**ON-SITE SEWAGE DISPOSAL SYSTEM
HOWARD COUNTY HEALTH DEPARTMENT
BUREAU OF ENVIRONMENTAL HEALTH**

SUBDIVISION: Linden Chapel Hills III LOT NUMBER: 11, Block B

ADDRESS: 4991 Morning Star Drive PROPERTY OWNER: Jonathan Seils

SEILS RESIDENCE
 4991 Morning Star Drive
 Addition and Renovation
 Dayton, Maryland 21036

C-1

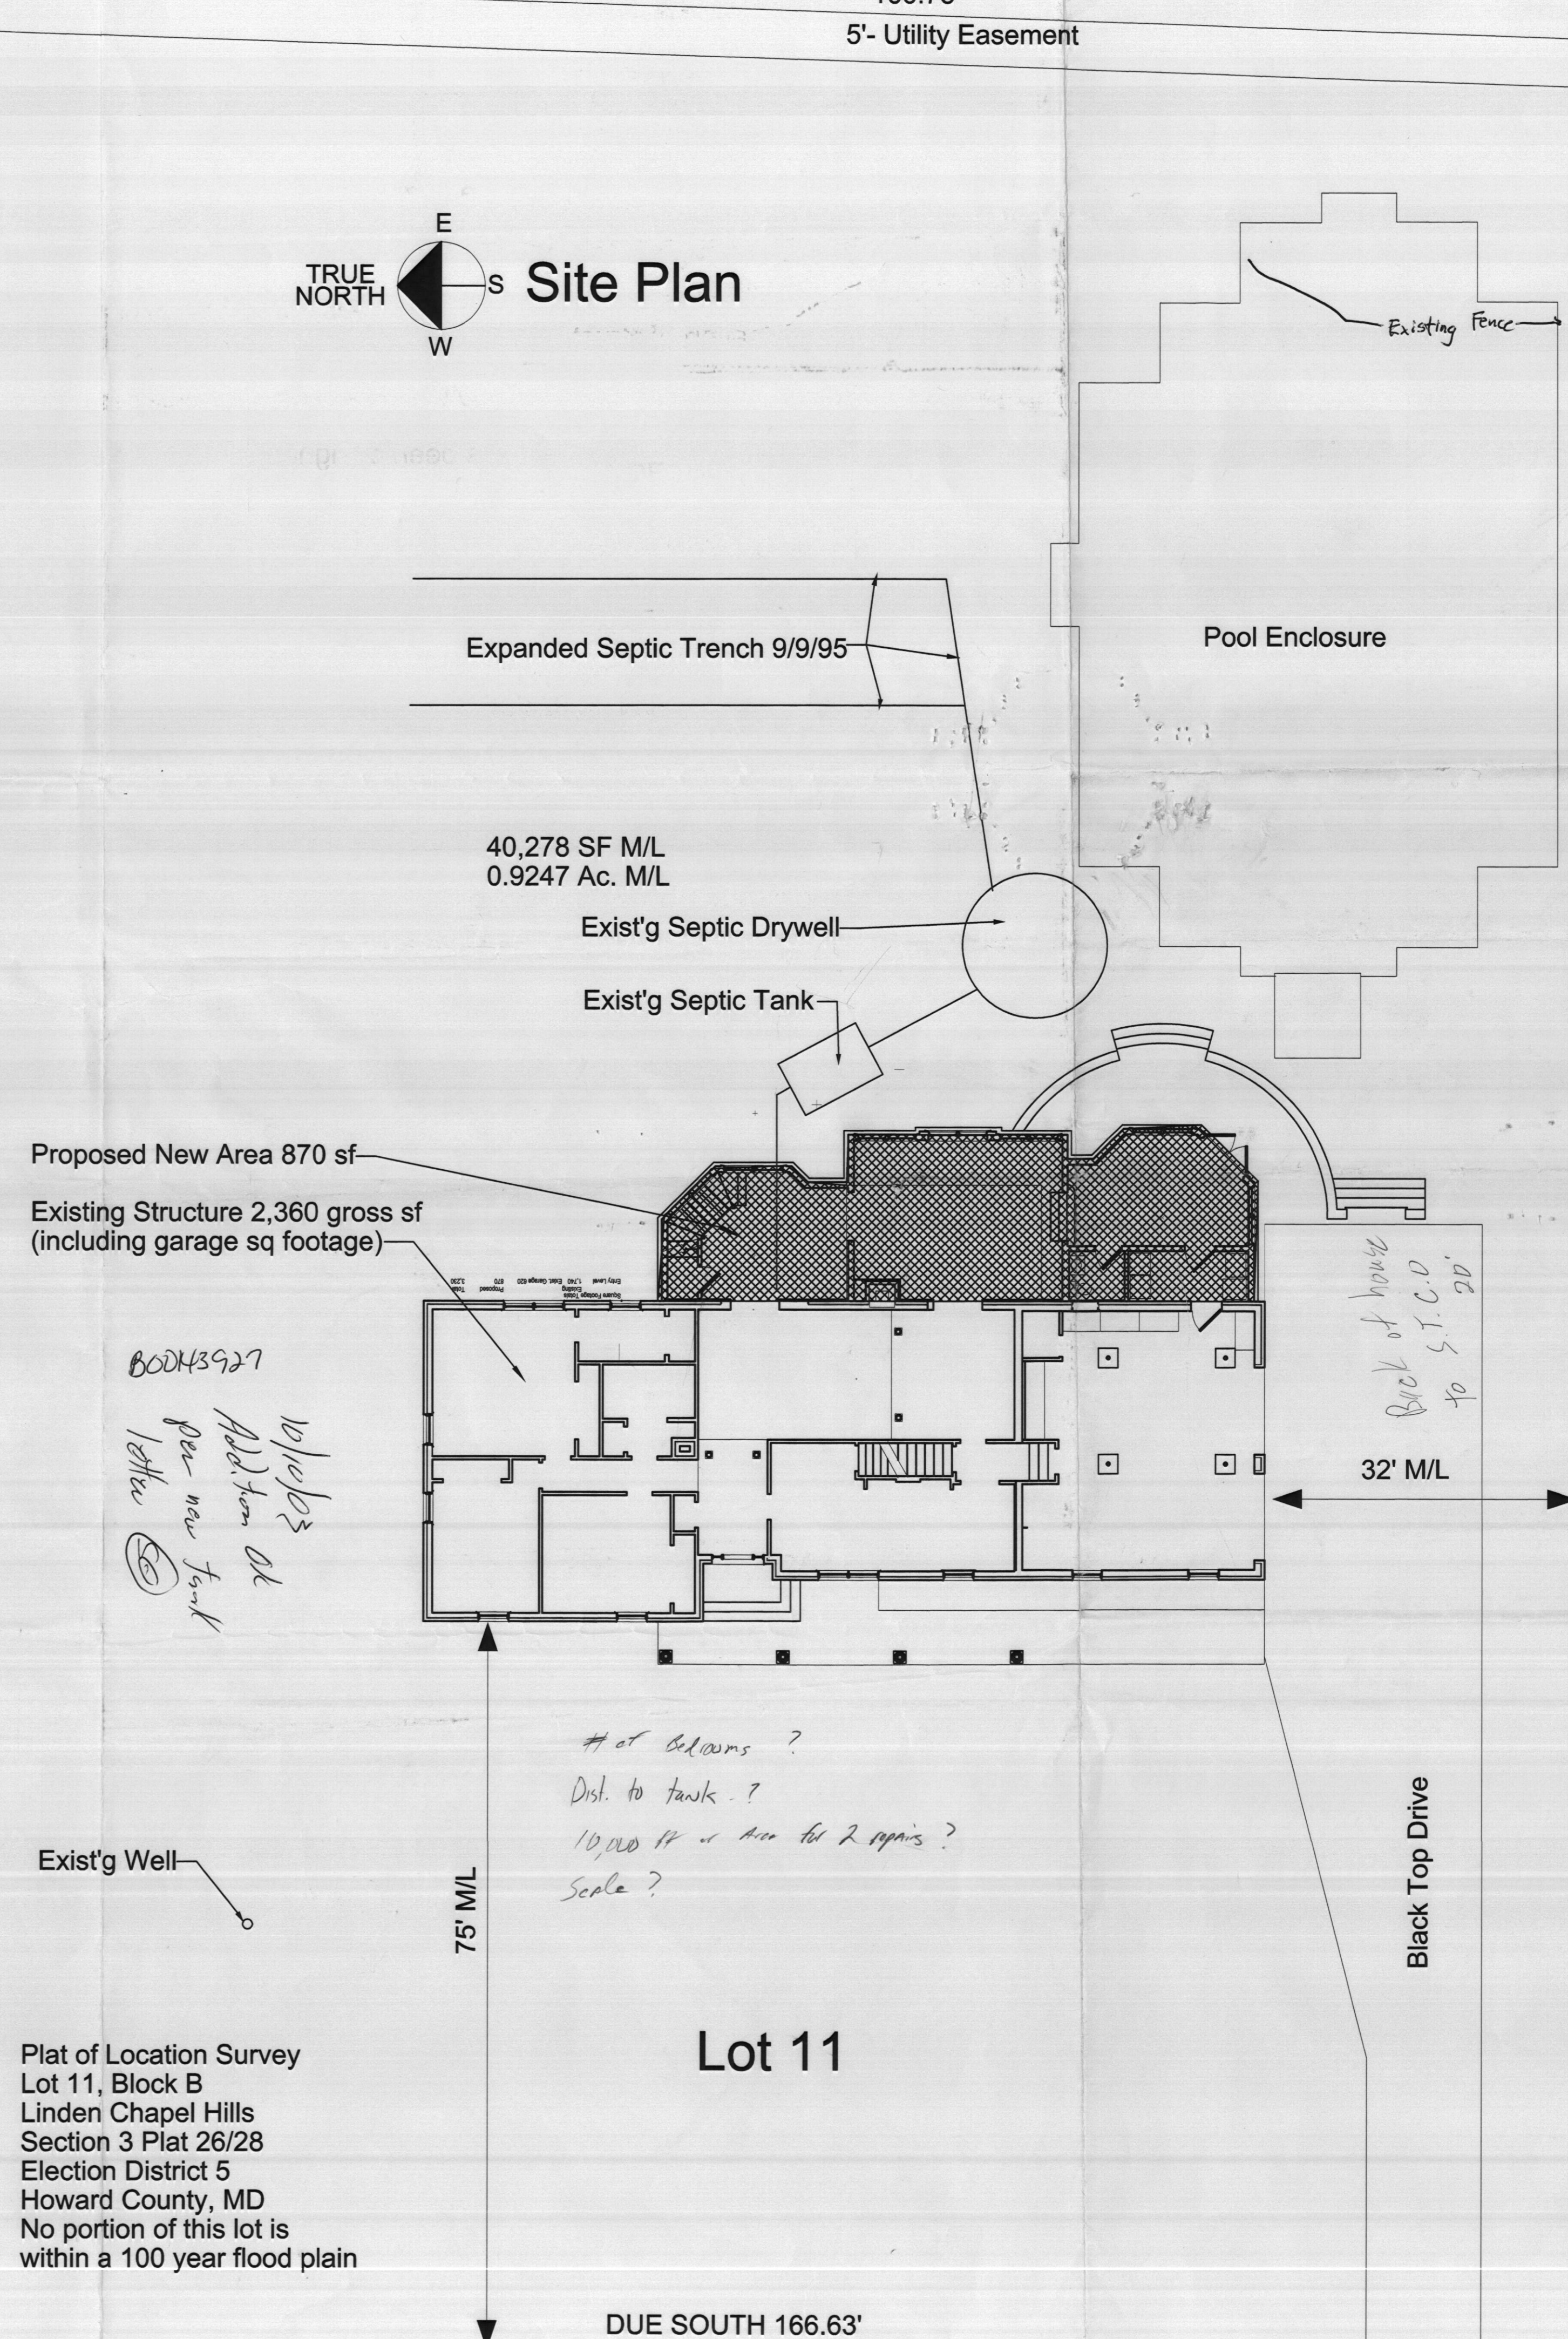
Handwritten notes:
 80043927
 10/10/03
 Addition ok
 per new tank
 letter

Handwritten notes:
 # of bedrooms?
 Dist. to tank?
 10,000 ft or more for 2 repairs?
 Scale?
